Report: TAB Report
Function: Test, Adjust, & Balance
Date: 12/05/2025
Completed By: National TAB

11-03-25 WAWA #7618 LOUISVILLE, KY

Project: 11-03-25 WAWA #7618 LOUISVILLE, KY

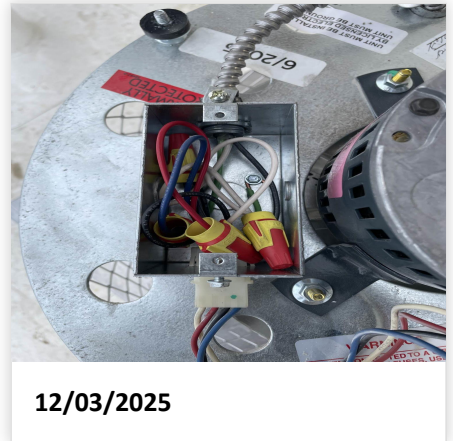
Issue Name : EF Speed Controller
Description : Neither EF-1 nor EF-2 is equipped with a speed controller as specified in EF schedule. Unable to adjust fan speeds. EF flow adjusted using dampers.
Created By : National TAB **Assigned To :** National TAB - Jordan Best
Status : Open
Priority : High **Asset Tag :**
Originated Date : 12/03/2025 - Jordan Best - National TAB
